**Re: PETITION FOR JURISDICTION OVER A RENEWABLE FACILITY BY  
ANTRIM WIND ENERGY, LLC - DOCKET 2014-05**

**PETITION FOR JURISDICTION OVER A RENEWABLE FACILITY BY ANTRIM WIND  
ENERGY, LLC**

**PREFILED DIRECT TESTIMONY OF LISA LINOWES ON BEHALF OF  
THE WIND ACTION GROUP**

**APRIL 13, 2015**

# Antrim Limited Partnership Conservation Easement Map

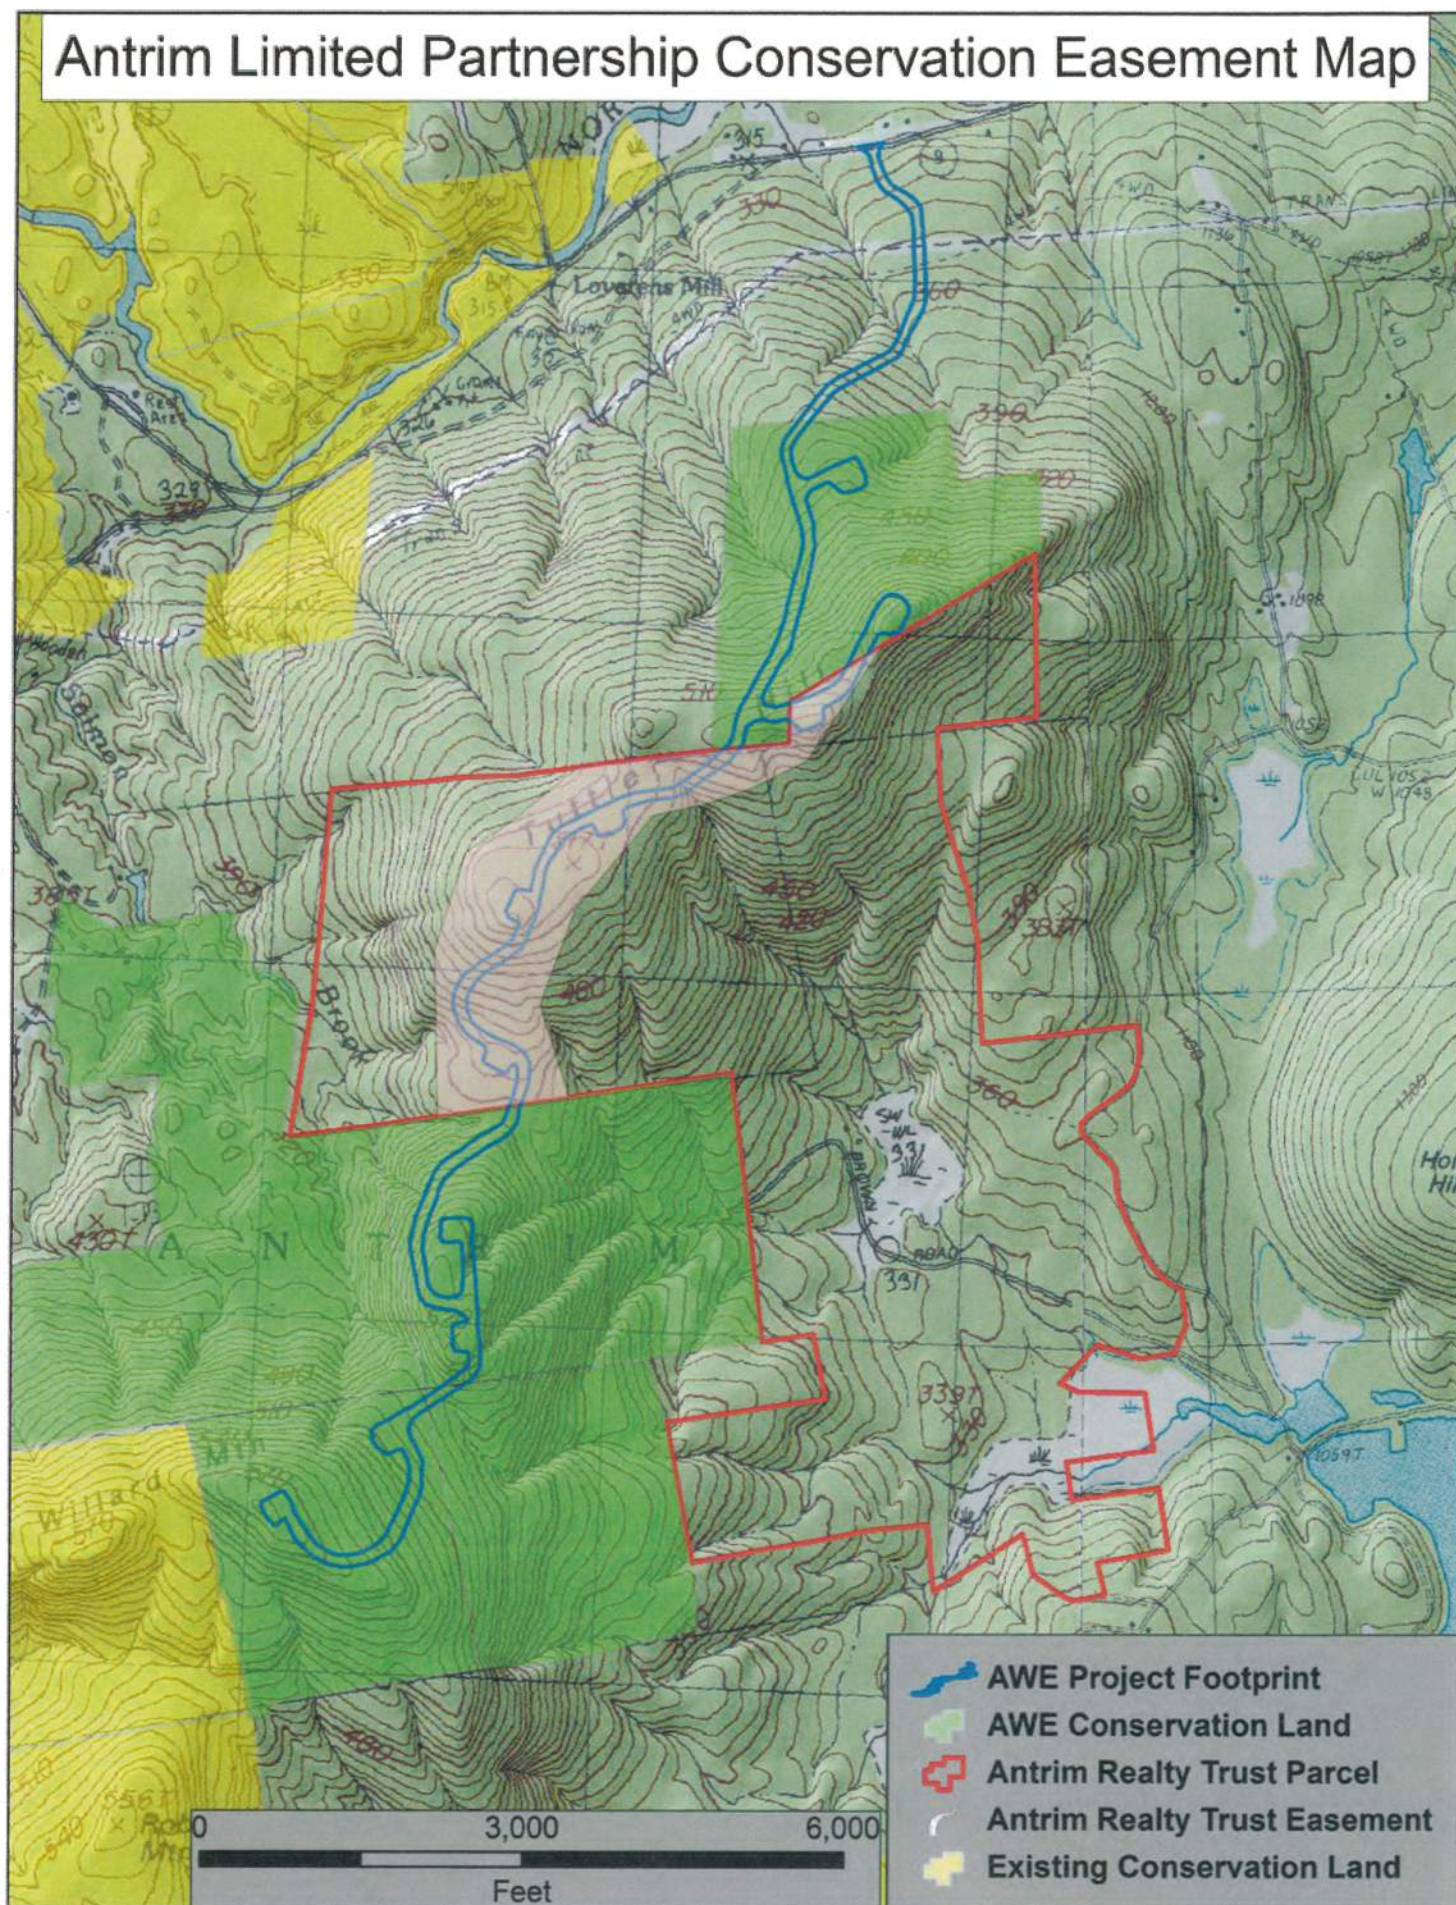
15 Appendix B attached shows the proposed conservation lands submitted to the Committee  
16 under Docket 2012-01 and the amended map that includes the added 100 acres<sup>6</sup>. In 2013, AWE  
17 stated in the record that the added 100-acres would encompass turbines 3, 4, 5 and 6. Without a  
18 current map depicting the conservation land, we cannot be certain what land Mr. Kenworthy is  
19 referring to.
